SUBJECT: Central and Southern Florida Project, Comprehensive Everglades Restoration Plan, Broward County Water Preserve Area, Final Integrated Project Implementation Report and Environmental Impact Statement (March 2007) --Documentation of Review Findings

DOCUMENTATION OF REVIEW FINDINGS

CENTRAL AND SOUTHERN FLORIDA PROJECT COMPREHENSIVE EVERGLADES RESTORATION PLAN BROWARD COUNTY WATER PRESERVE AREA

FINAL INTEGRATED PROJECT IMPLEMENTATION REPORT AND ENVIRONMENTAL IMPACT STATEMENT MARCH 2007

FIGURE 6-4: SAW GRASS MARSH HABITAT UNITS

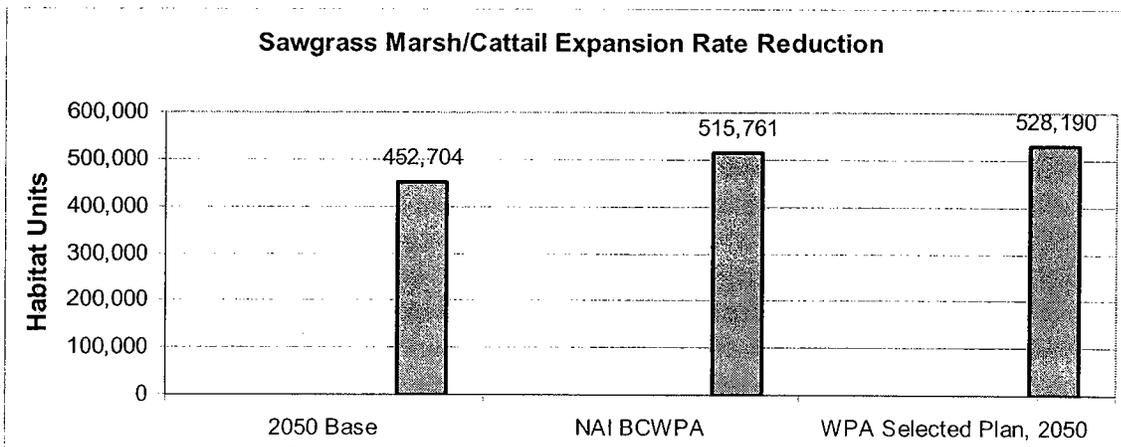
4e. Comment: NAI Display – Figure 2-13. Define the labels for all 7 bars in Figure 2-13. Are the 516,000 Saw grass Marsh habit units in the “NAI BCWPA” bar the increment above the future without-project condition? It appears that the actual increment is only about 63,000 habit units; i.e., the difference between the “2050 Base” and “NAI BCWPA” amounts. Average annual habit units should be displayed.

CESAJ Response: This comment is in regards to two separate figures on that page, Figure 2-12 and Figure 2-13. Figure 2-12 shows the saw grass marsh habitat units and Figure 2-13 shows the snail kite habitat units. The bars on each of the figures are labeled. On Figure 2-12, the bars are labeled from left to right as follows: 2050 Base, NAI BCWPA and WPA Selected Plan, 2050. On Figure 2-13, the bars are labeled from left to right as follows: NSM/Sens4, 2000B3, 2050B3 and NAISAP. These figures are located in Section 6 of the final PIR and are Figures 6-4 and 6-5.

Stage Hydrographs for C-9 Reservoir

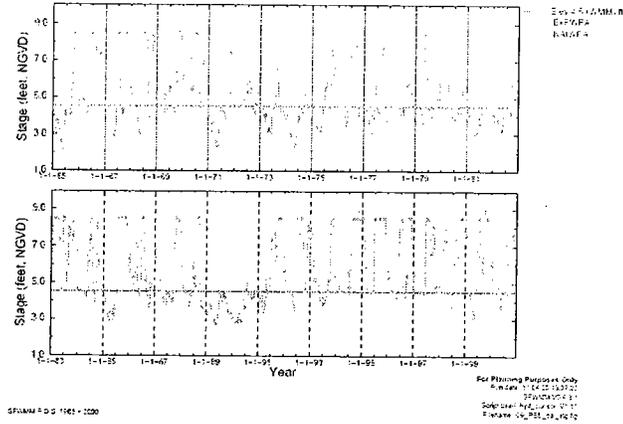
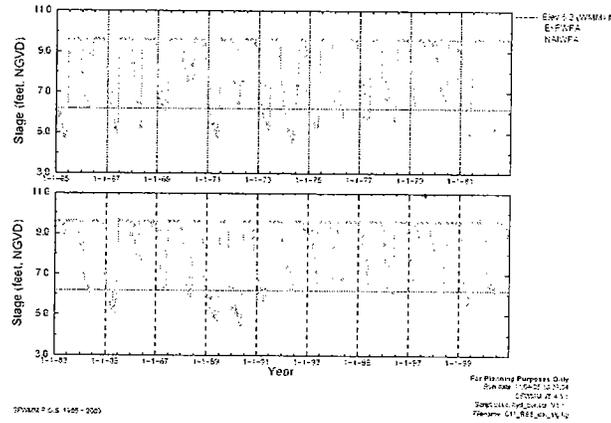
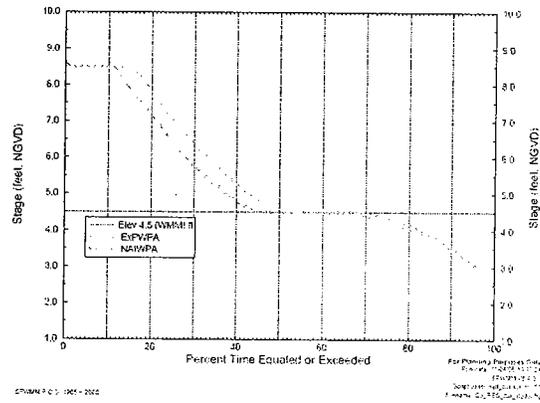
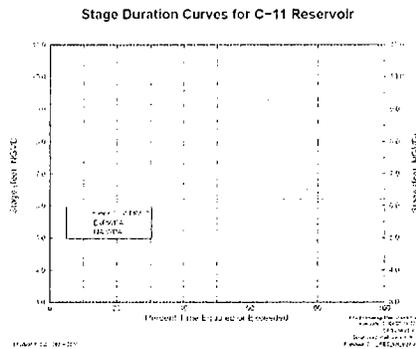
Discussion/Action Required: Include the information from the response in the PIR. The table of different model results and the figures should be supported with explanations of the simulations and their differences.

Action Taken: Section 6.1.4 of the PIR has been revised and explanations are provided to support the figures.
